Subject: Limerick Generating Station, Units 1 & 2  
Information for Containment Systems Branch (CSB)  
Primary Containment Negative Pressure Design Limit

Attached are draft changes to FSAR Section 6.2.1.1.4, Table 6.2-9 and Figures 6.2-19, 20 which are being made as a result of discussions at the referenced meeting.

LIMERICK GENERATING STATION  
UNITS 1 AND 2  
FINAL SAFETY ANALYSIS REPORT

TABLE 6.2-9

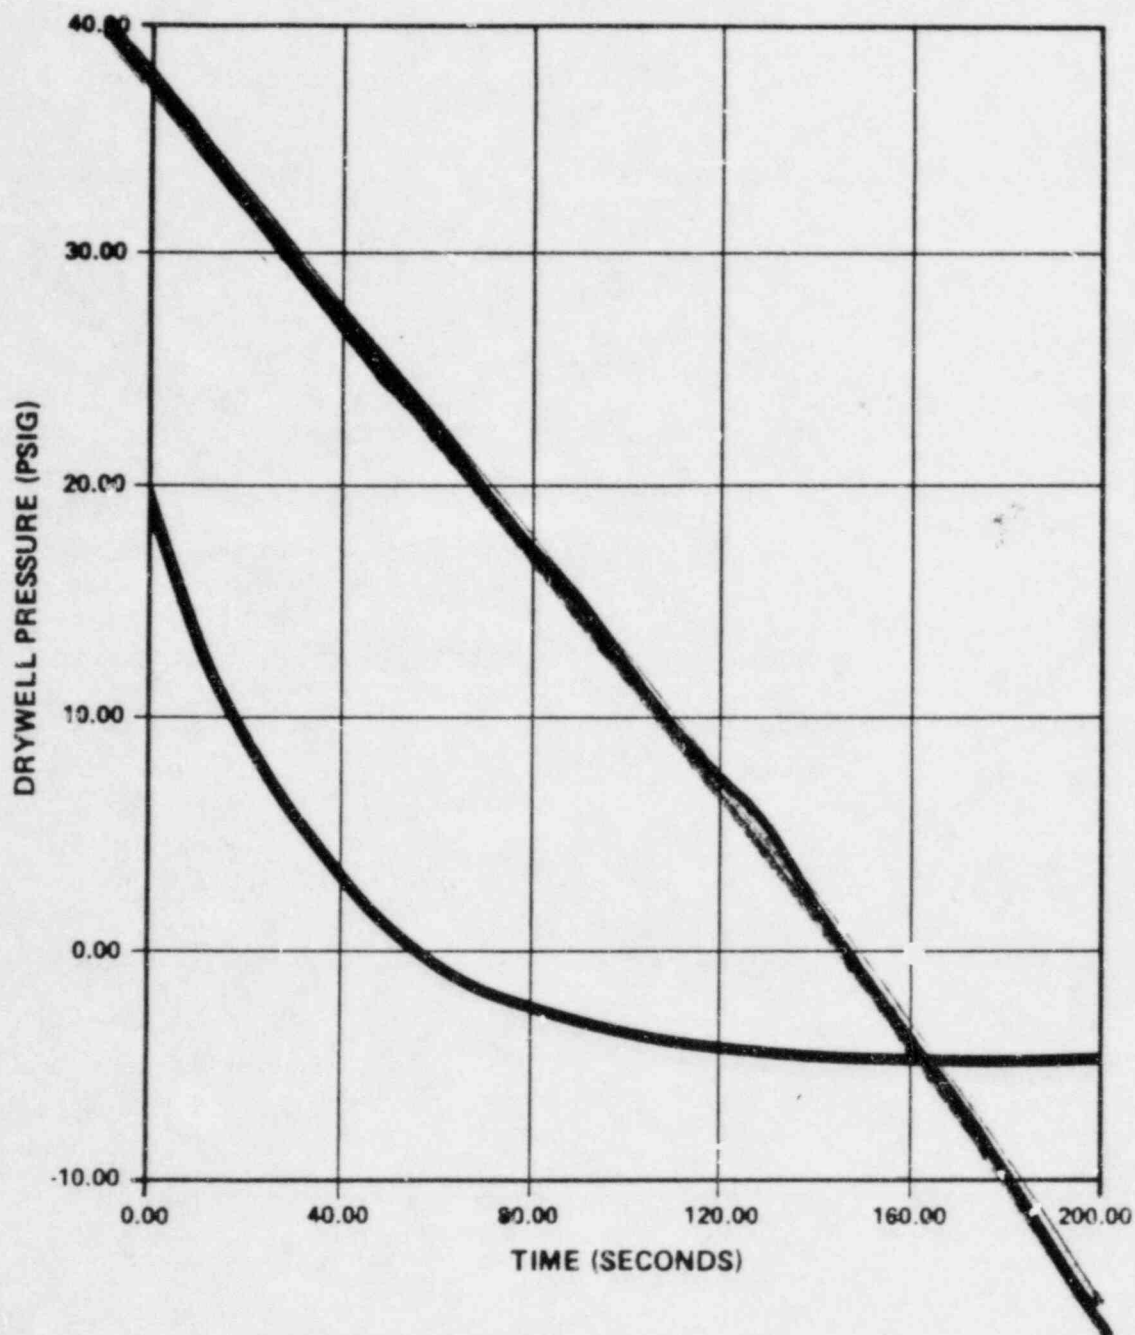
<u>t<sub>oo</sub>(1)</u>	<u>t<sub>o</sub>(2)</u>
<u>Drywell</u>		
(3) Volume, ft <sup>3</sup>	242860	<del>248,950</del> 242860
Pressure, psia	137 <del>144.8</del>	<del>34.14</del> 35.61
Temperature, °F	135 <del>150</del>	<del>257.8</del> 260.3
Relative humidity, %	90 <del>100</del>	100
Spray rate, gpm/number of trains	0/0	9500/1
<u>Wetwell</u>		
Volume - Vapor region(3), ft <sup>3</sup>	137132	<del>161,350</del> 137132

- Suppression pool(3), ft <sup>3</sup>	127507	<del>118,655</del> 127507
Pressure, psia	13.7 <del>14.8</del>	<del>29.59</del> 31.28
Temperature, °F	50	50
Relative humidity, %	100	100
Suppression pool free surface area, ft <sup>2</sup>	4974 <del>5277</del>	<del>5277</del> 4974
<u>Wetwell-to-Drywell Vacuum Breakers</u>		
Number of valve assemblies	3 of 4	
Flow area per assembly, ft <sup>2</sup>	2.05	
Flow coefficient (4)	<del>0.35</del> .495	
Vacuum breaker <del>lifting</del> pressure(4)(psid) full open	<del>5</del> 4.48	
<u>RHR System - Drywell Sprav Mode</u>		
Service water flow rate, gpm	9000	
Service water temperature, °F	<del>32.5</del> 40	
Heat exchanger effectiveness	0.249

(3) ~~Low~~ water level(4) ~~Using this value, rather than the value 4974 ft<sup>2</sup> as listed in Table 6.2-1, has a negligible effect on results~~(5) ~~Using value is more conservative than using the value in Table 6.2-2~~

FIGURE 6.2-19

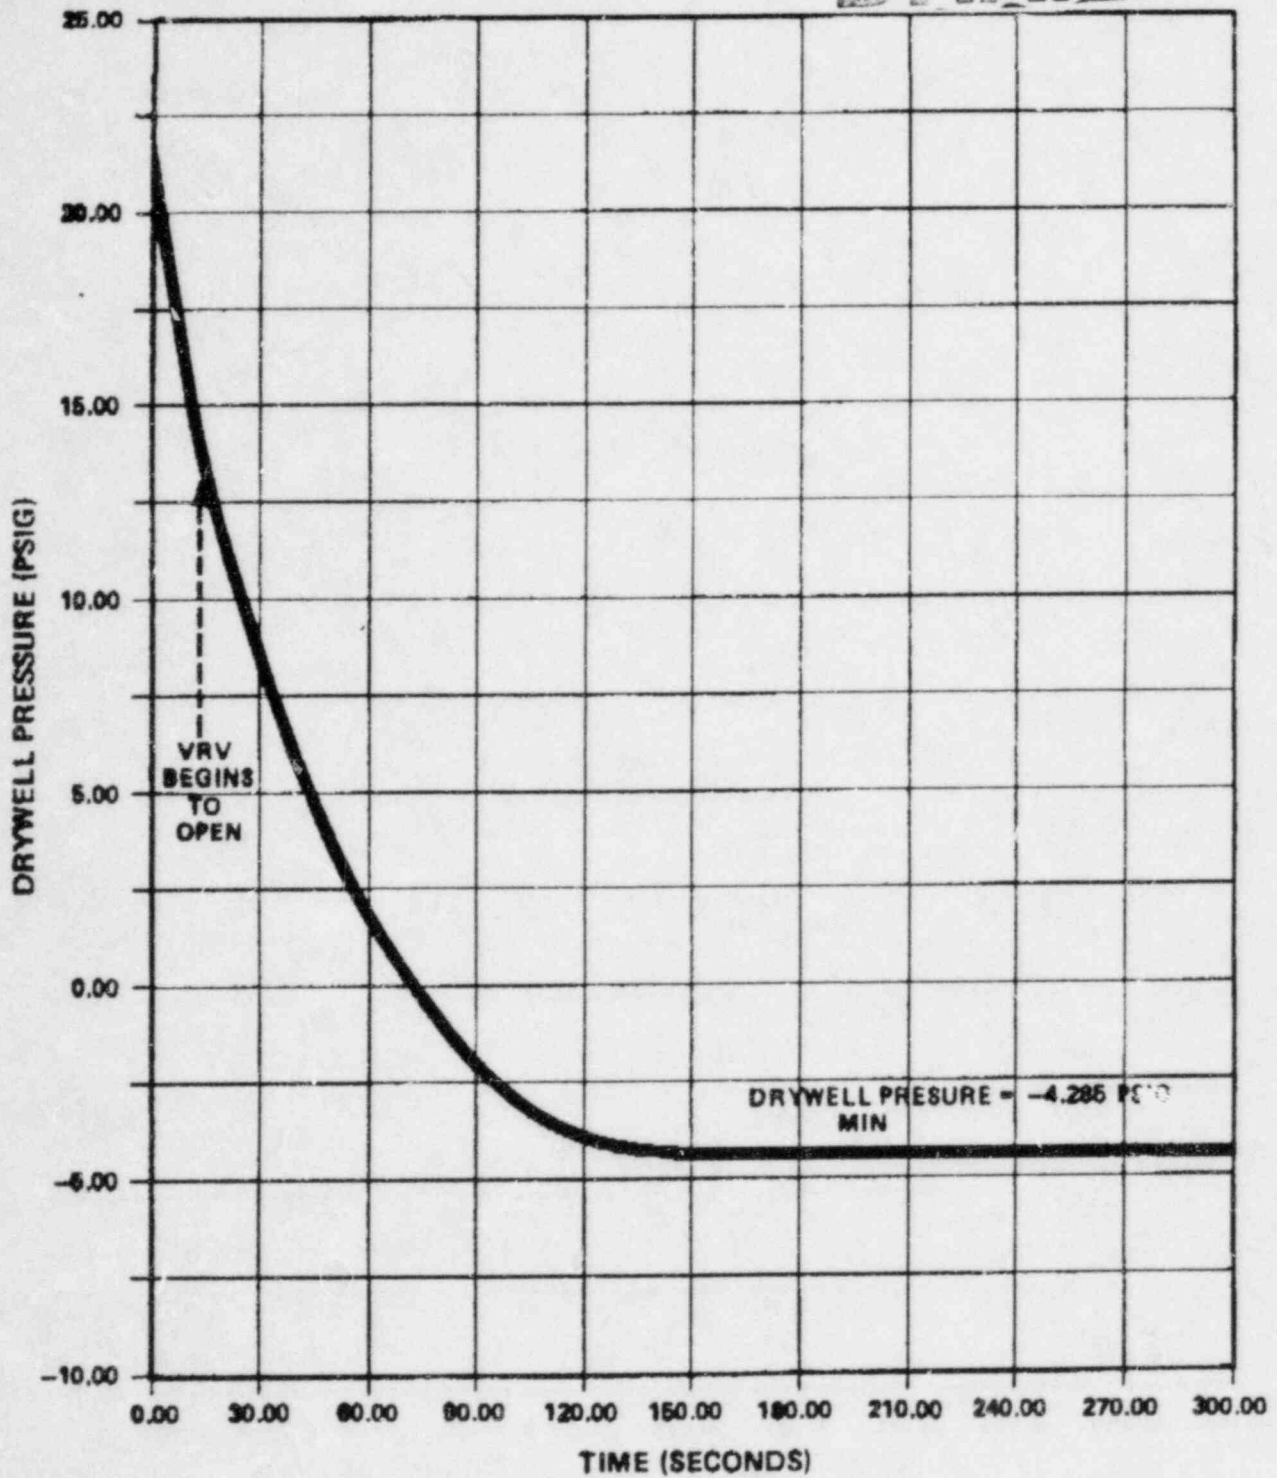
DELETE & REPLACE WITH ATTACHED DRAET

FIGURE 6.2-20

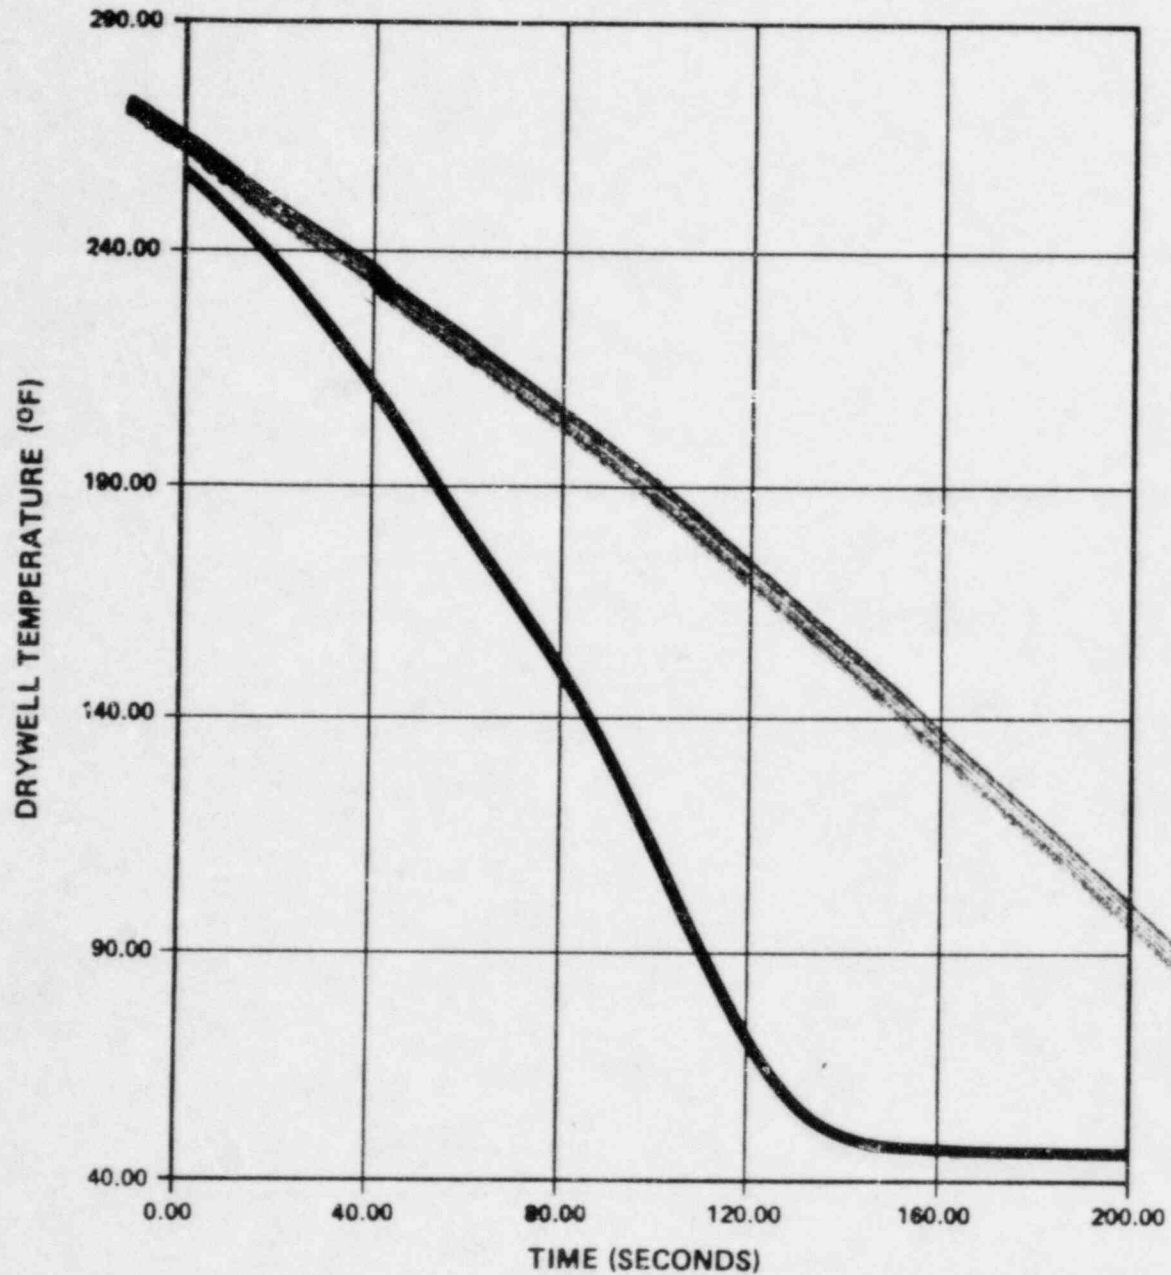
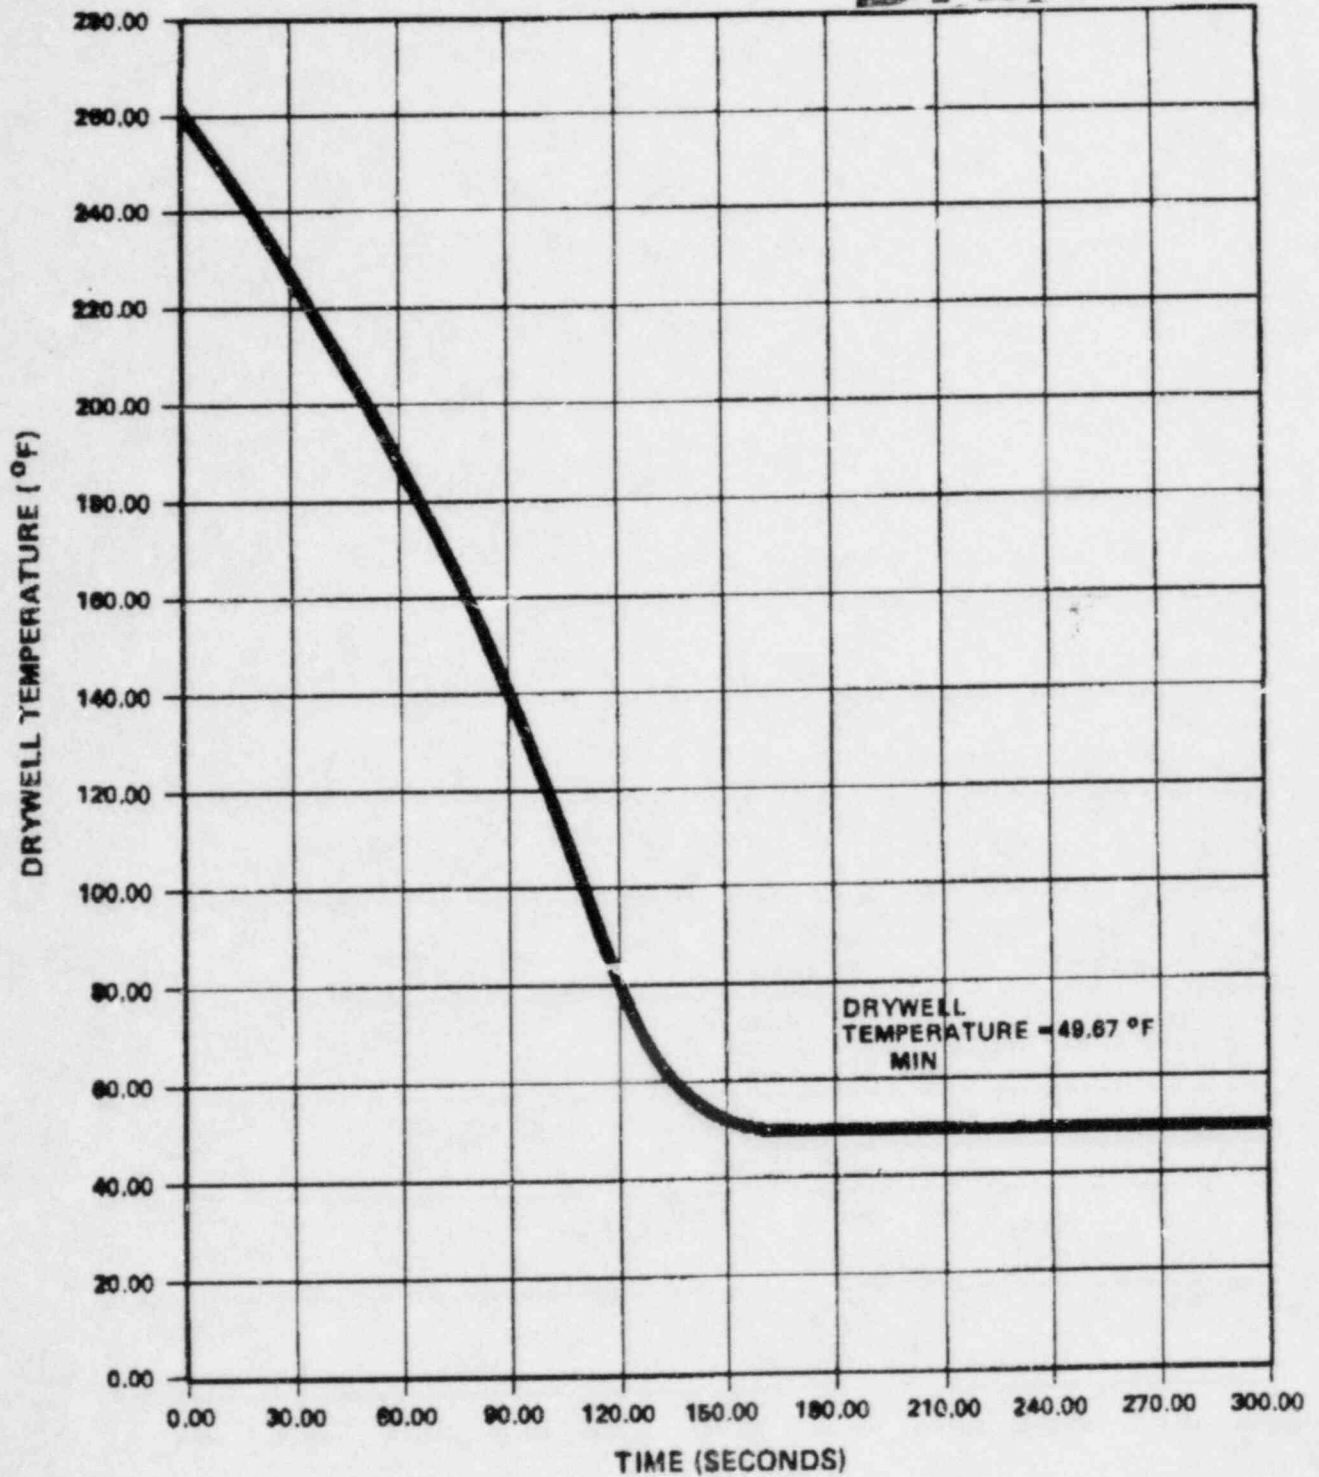
DELETE & REPLACE WITH ATTACHED
